Dresden Nuclear Power Station, Units 2 and 3
Facility Operating License Nos. DPR-19 and DPR-25
NRC Docket Nos. 50-237 and 50-249

Subject: Request for Changes Related to Technical Specifications Section 3.4.9, "Reactor Coolant System Pressure and Temperature (P/T) Limits"

APPENDIX A
Pressure-Temperature Curves,
Amendment Request to Support Operation to 54 Effective Full Power Years
Dresden Nuclear Power Station

Markup of Technical Specification Pages for Proposed Changes

Figure 3.4.9-1 (Page 1 of 1)
Non-Nuclear Inservice Leak and Hydrostatic Testing Curve
(Valid to 32 EFY)

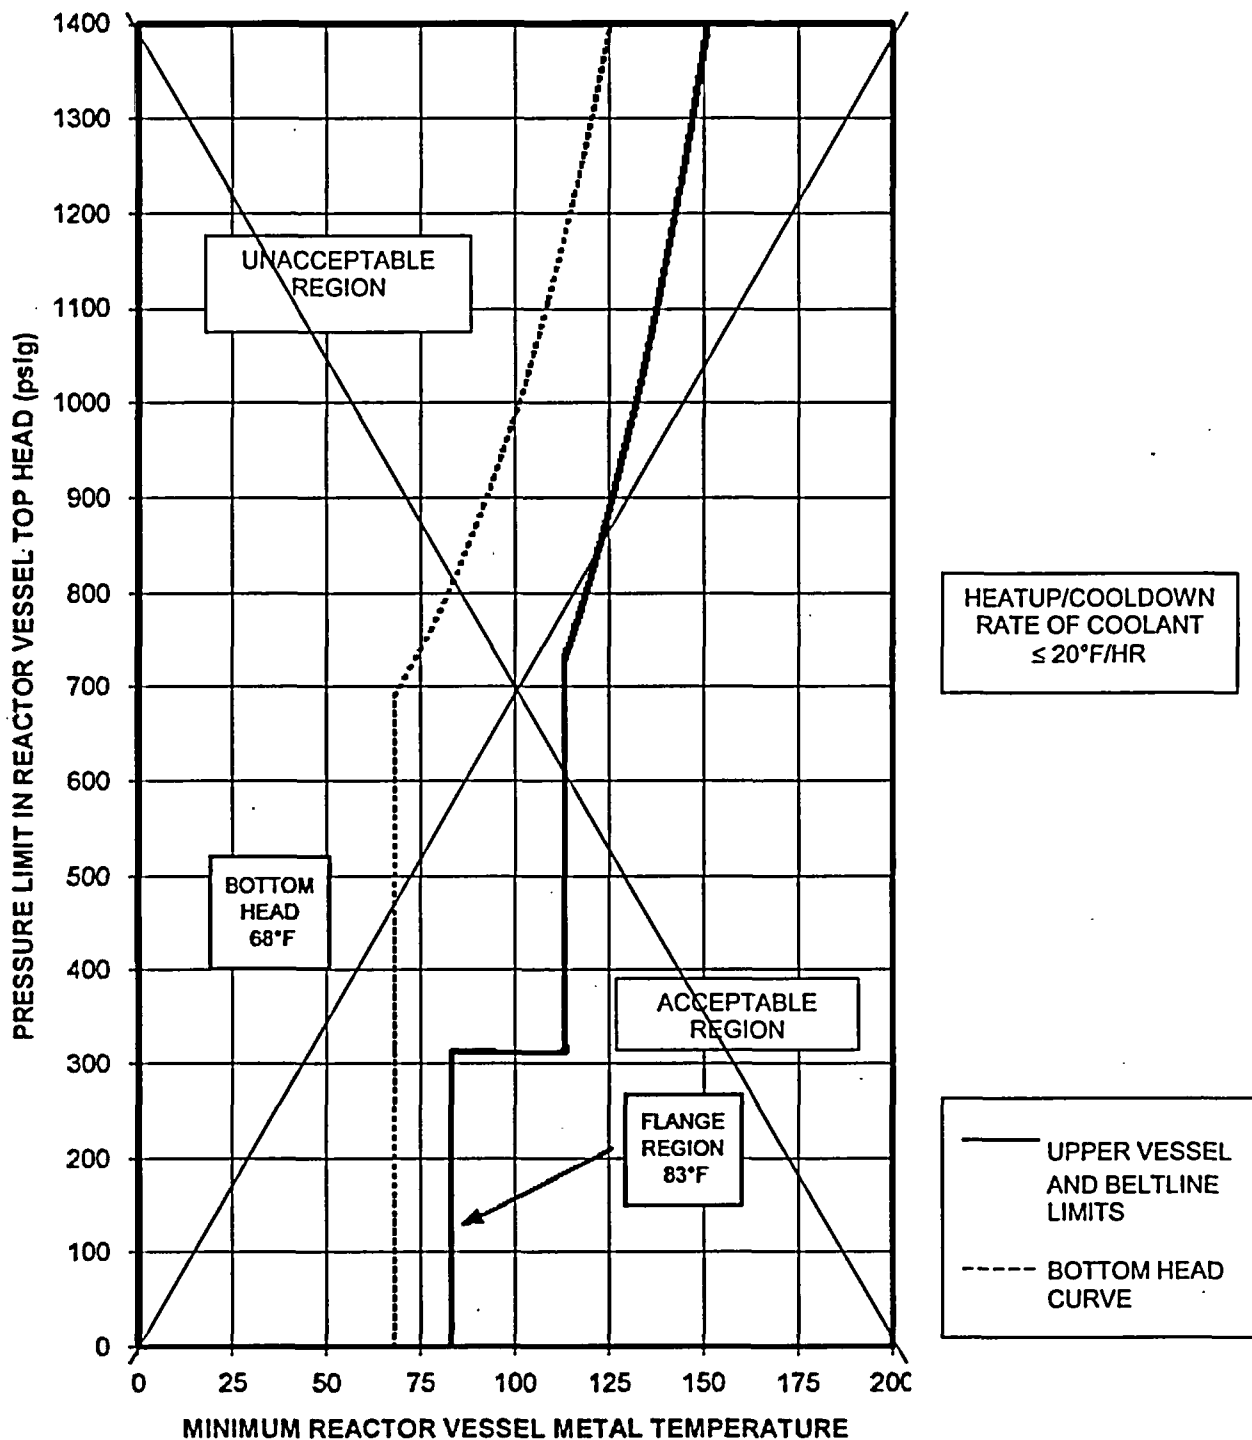
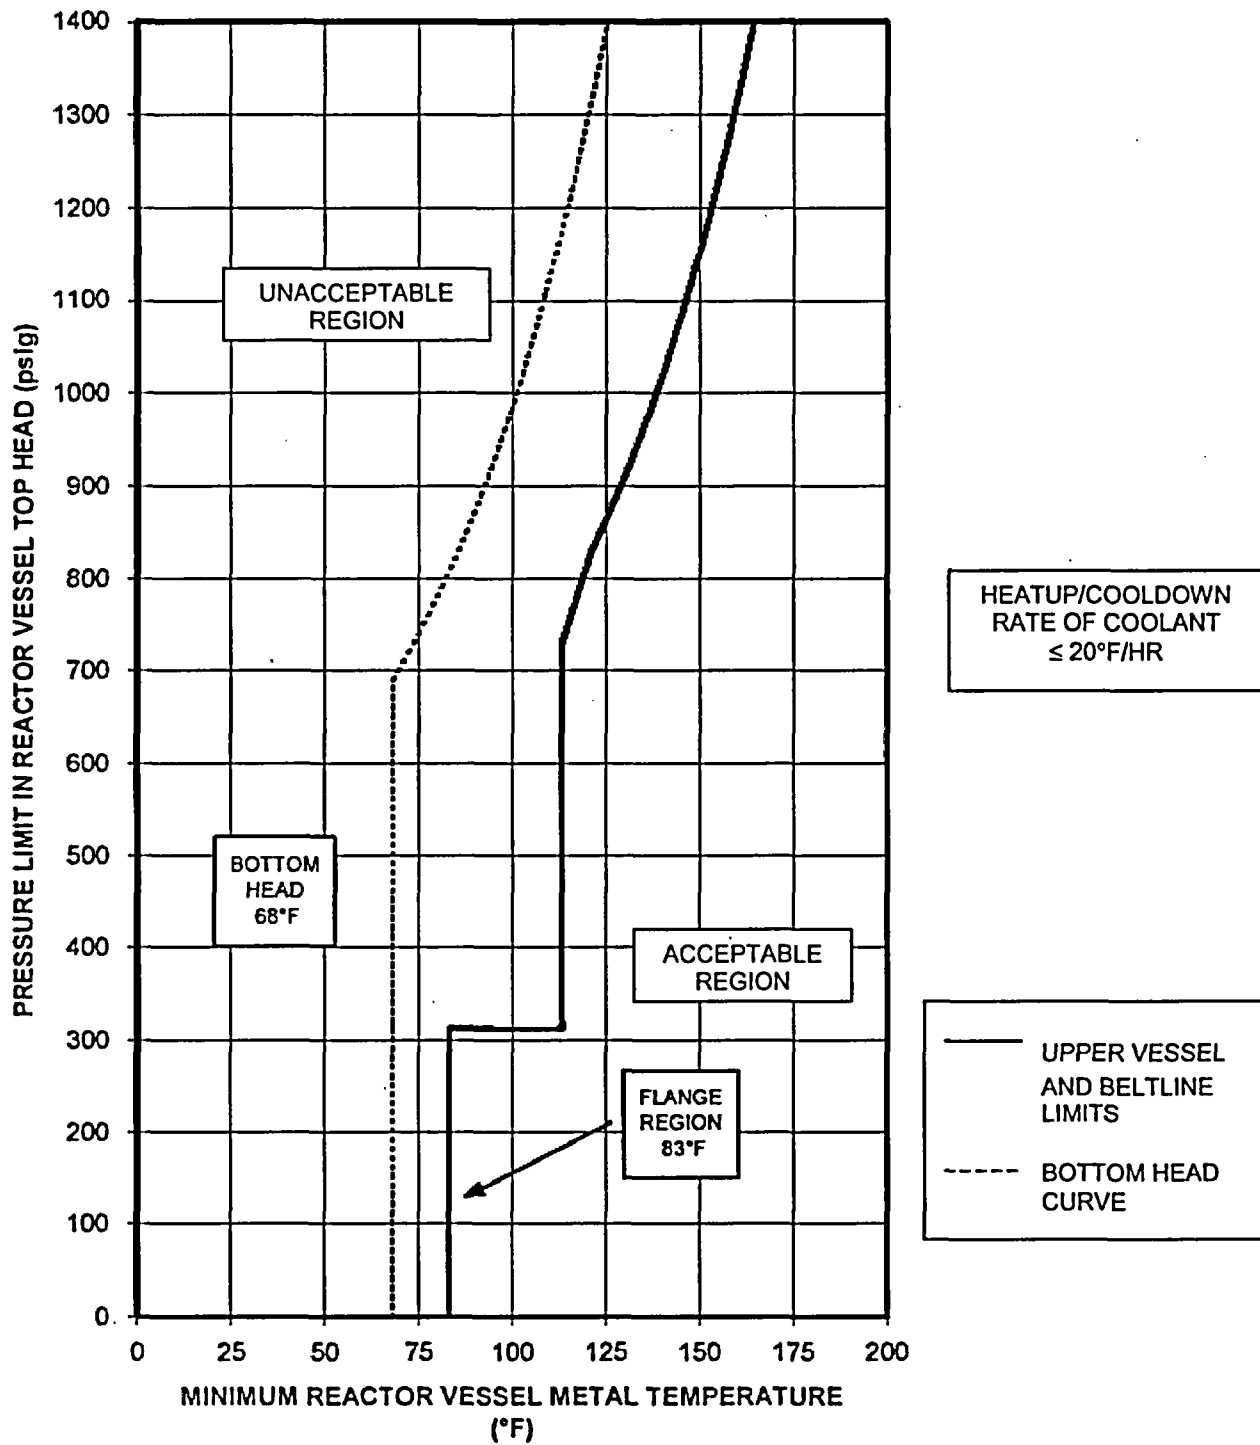
- Replace the current TS Figures 3.4.9-1 through 3.4.9-3 with revised TS Figures 3.4.9-1 through 3.4.9-3. The revised P/T curves are applicable to 54 effective full power years (EFPY) as determined for a 40-year license with a 20-year renewed period.

Figure 3.4.9-1 (Page 1 of 1)
Non-Nuclear Inservice Leak and Hydrostatic Testing Curve
(Valid to 54 EFPY)
